PLANNING ASSESSMENT REPORT

SUBDIVISION, MULTI DWELLING HOUSING, RESIDENTIAL FLAT BUILDING AND RECREATION AREA

103 PRINCE STREET, ORANGE

PREPARED ON BEHALF OF:
ORANGE CITY COUNCIL

Figure 13: Public Park - Amended Design

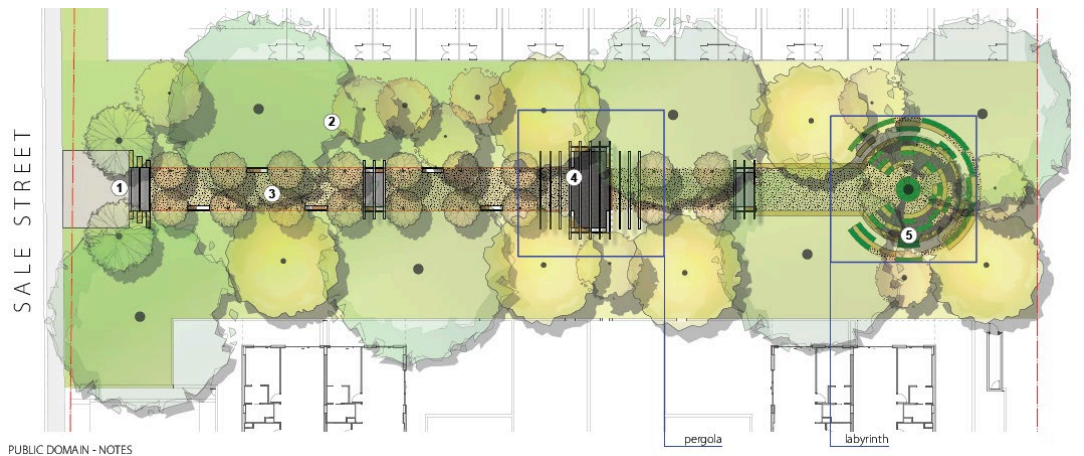
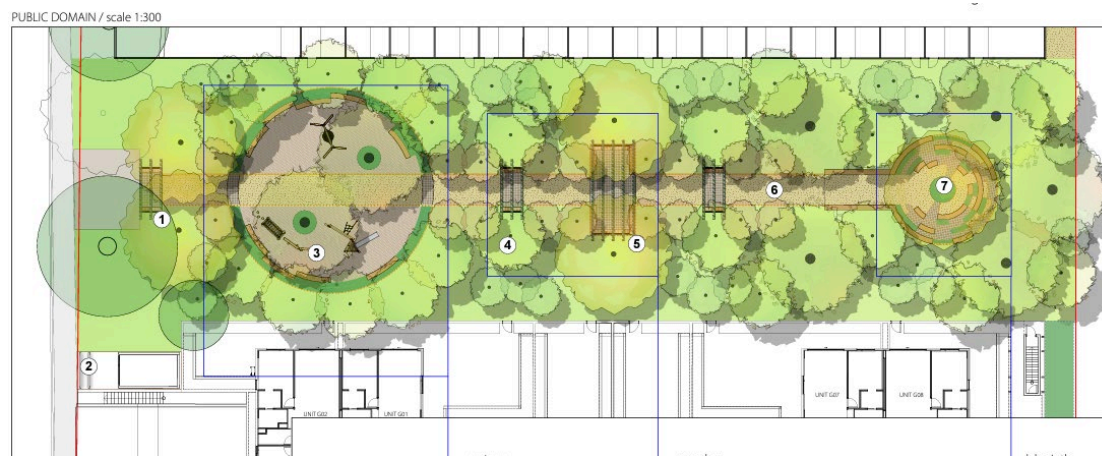
The initial design included a central spine of hard landscaping comprising a path and pergola structures leading to a labyrinth feature at the eastern end.

The initial design omitted certain elements envisioned by the DCP such as landscaped areas for gathering, an area for informal children's play and BBQ area

The design was subsequently adjusted to include an area for nature play with the introduction of timber play equipment.

Figure 37: Building envelopes highlighting the encroachment on level 4 East Elevation

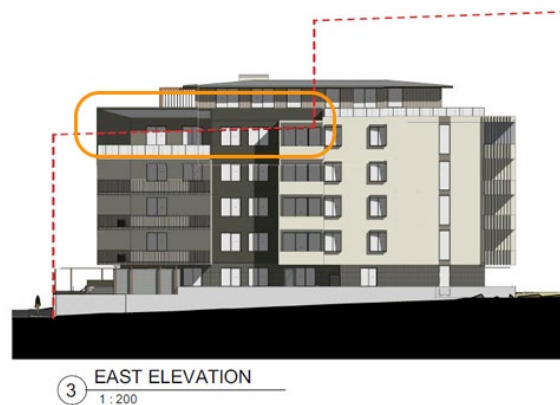
The above analysis relates only to the encroachment above level 4 (i.e. the penthouses), when a review of the plans indicates there is also an encroachment below this level on level 4 across the full length of the building as shown in the below figures.

Therefore, the clause 4.6 request does not meet the necessary requirements at the first step, and it is not considered necessary to provide further analysis of the clause 4.6 request against the remaining sections of the clause.

Figure 42: Garbage Collection Arrangements

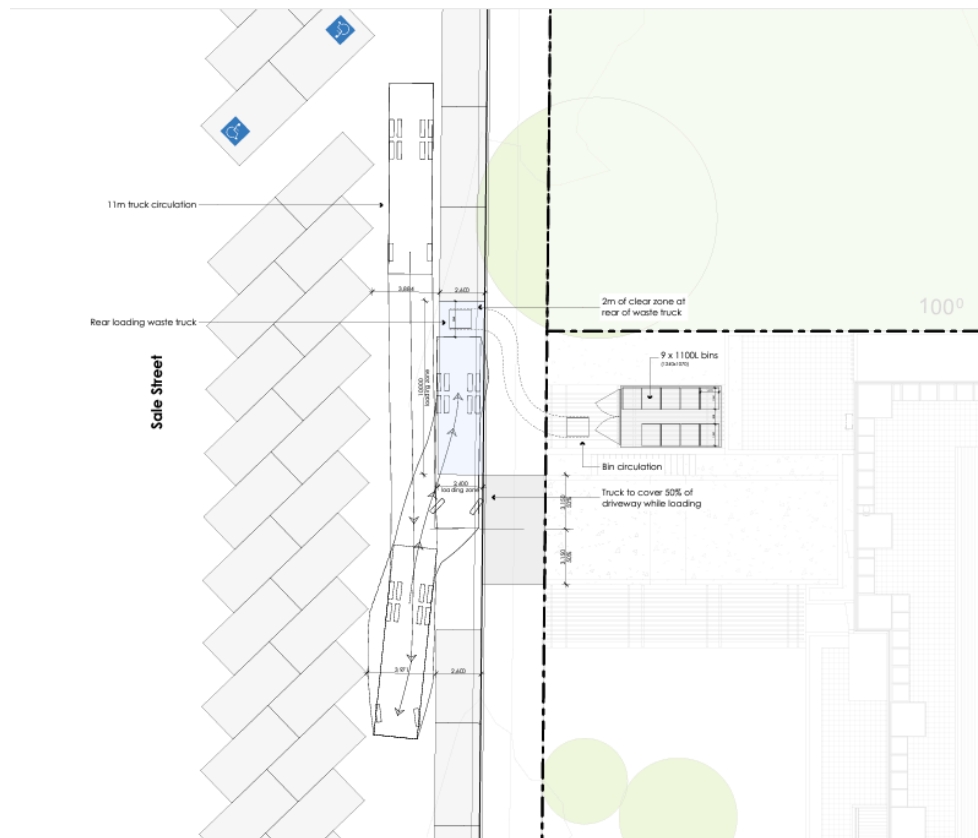
Given the existing traffic arrangements in Sale Street with centre herringbone pattern parking, it's likely that this arrangement will present undesirable traffic impacts whilst the collection is occurring. It's also likely, based on available information, that an area of no parking or a loading zone would need to be established within the street to facilitate this arrangement which would reduce the amount of on-street parking; although, this could be managed via a time limited loading zone and a management plan that required the collection of garbage to occur between certain times. Additionally, and not shown on the above referenced plan, is the presence of two street trees where this arrangement would likely necessitate their removal.
